Rezoning Application: PD 23-0992

**Hillsborough
County Florida**

Development Services Department

1.0 APPLICATION SUMMARY

8.0 PROPOSED SITE PLAN (FULL)

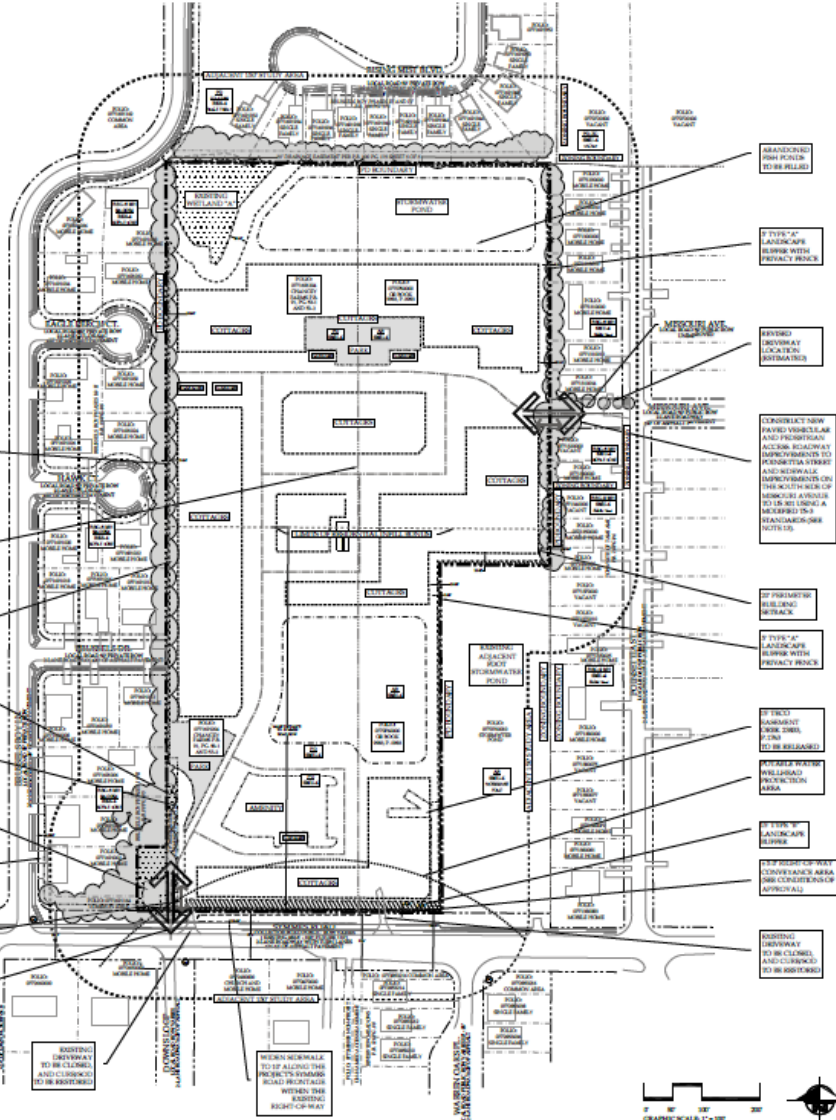
1. In the Lot Development Standards table, setbacks and building separations for corner lots shall be amended to match the front yard setback.
2. Prior to site plan certification, developer replace site plan call outs stating “+/-5.0’ RIGHT-OF-WAY CONVEYANCE AREA (SEE CONDITIONS OF APPROVAL)” to “+/-5.0’ RIGHT-OF-WAY CORRIDOR PERSERVATION AREA (SEE CONDCTIONS OF APPROVAL)”.

- Prior to site plan certification, developer replace site plan call outs stating “+/-5.0’ RIGHT-OF-WAY CONVEYANCE AREA (SEE CONDITIONS OF APPROVAL)” to “+/-5.0’ RIGHT-OF-WAY CORRIDOR PRESERVATION AREA (SEE CONDITIONS OF APPROVAL”.

The January 29, 2024 site plan and December 21, 2023 narrative have conflicting calculations for density using the residential infill bonus. The site plan has the correct calculations with the exception of the residential yield being broken down into 6 du/a and 3 du/a. The portion of the site that is requesting the 660 foot infill bonus is allowed up to 9 du/a and the remaining portions of the site are at the Future Land Use category densities of 4 du/a and 6 du/a (RES-4 and SMU-6 categories). Planning Commission staff have reviewed and the site plan total showing 123 units maximum for the entire site is correct with the breakdown of density calculations as shown above, per the Future Land Use Element.

FIGURE 1
PROPOSED IMPROVEMENTS

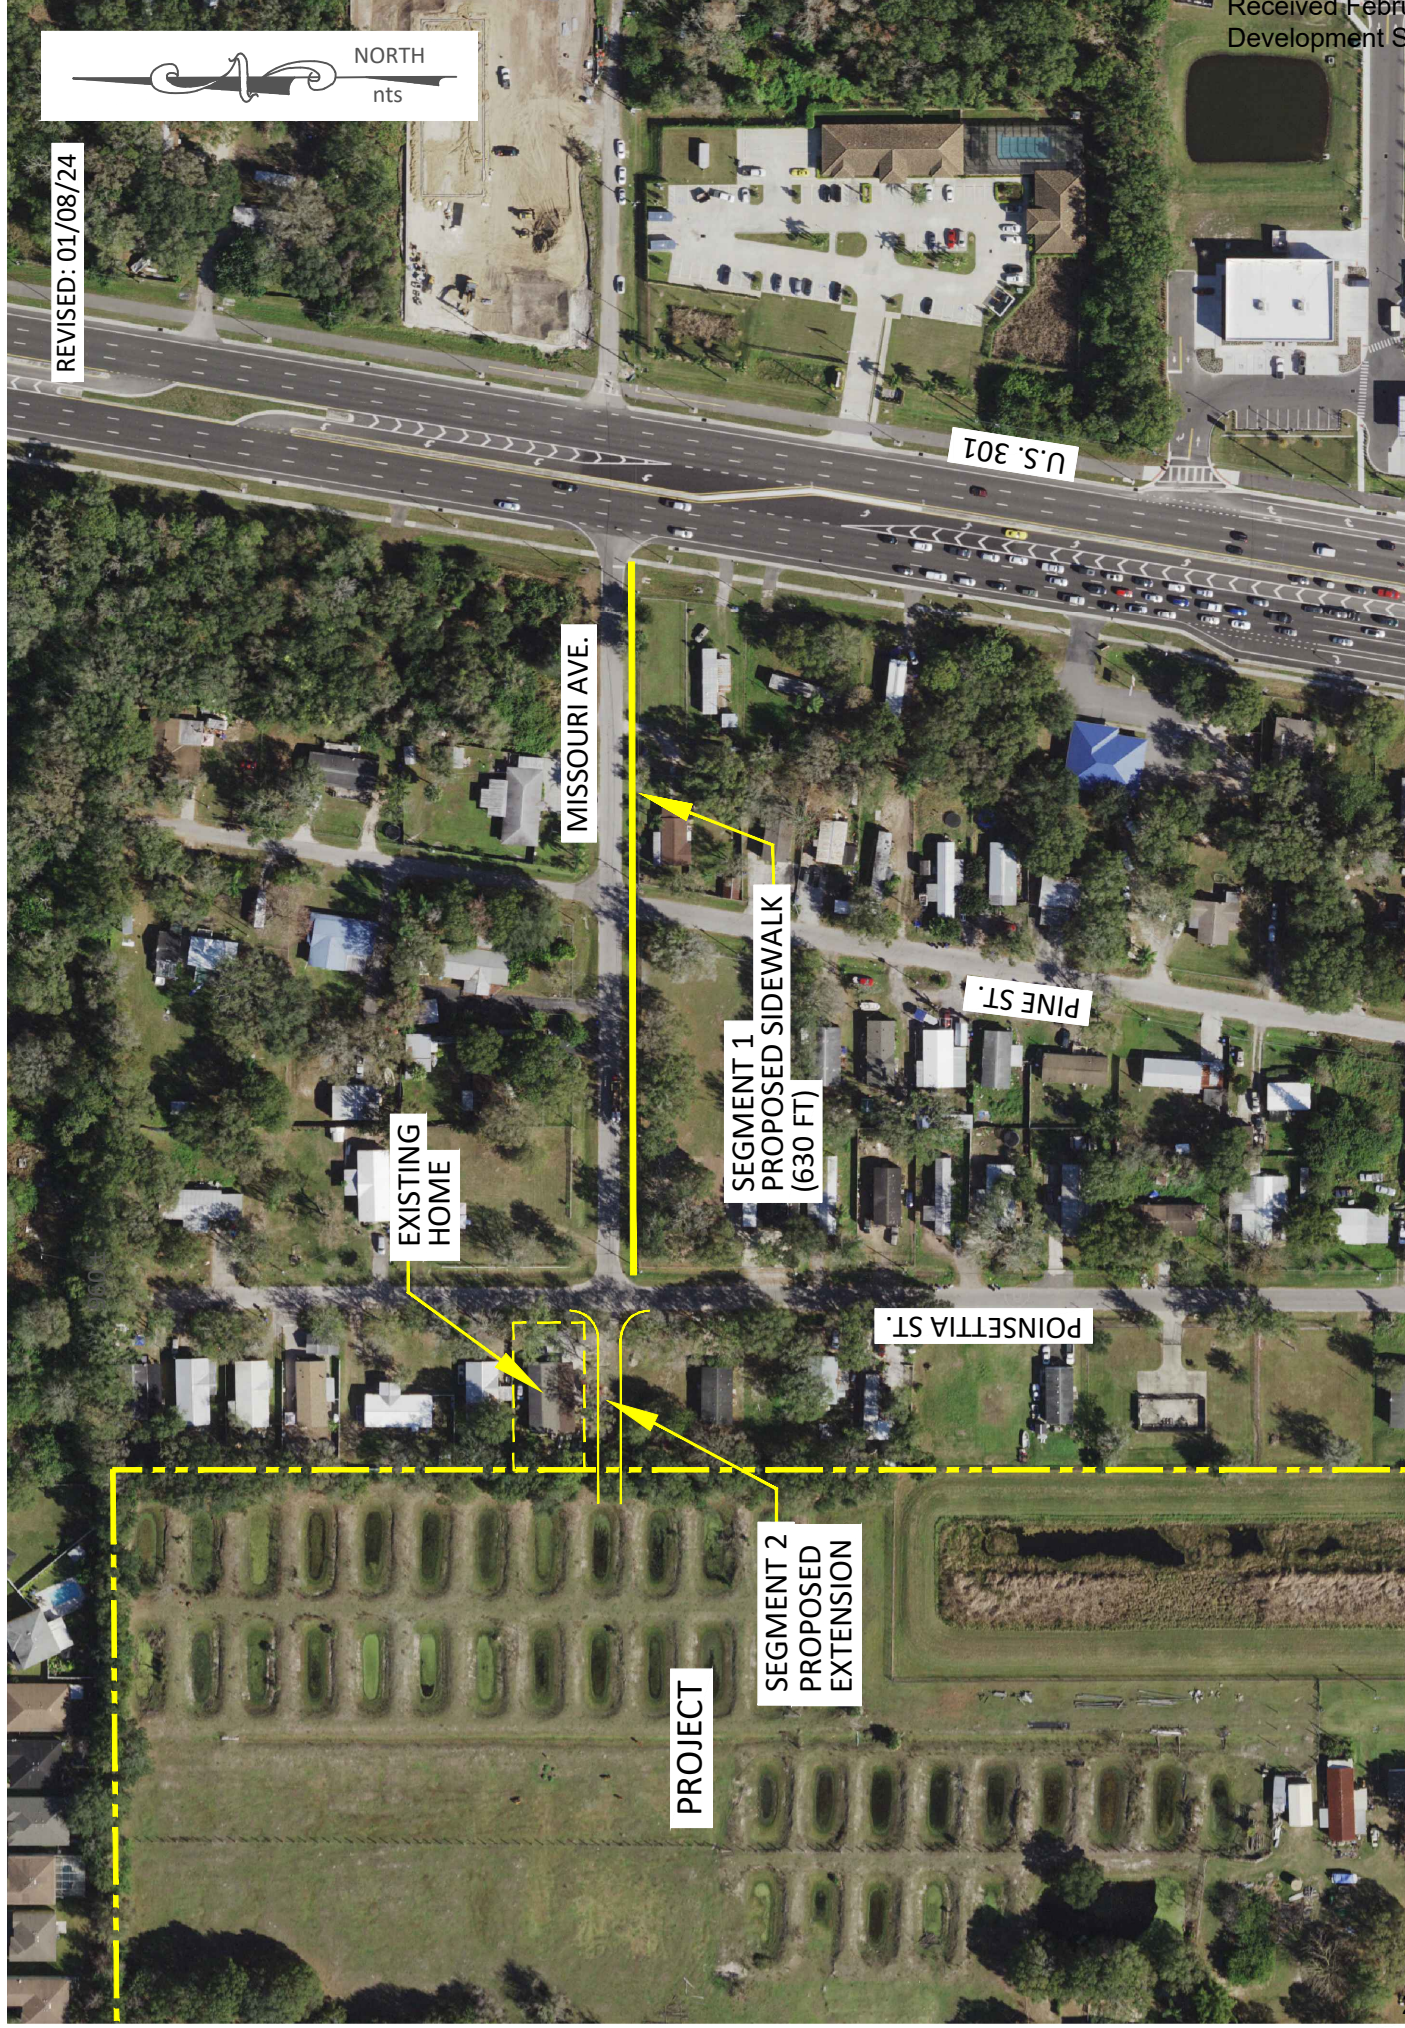
Figure 1 illustrates the limits of the proposed sidewalk.

- 1) There is an existing home that has the access and improvements that would affect the ability to provide the sidewalk. This segment of the roadway is approximately 130 feet.
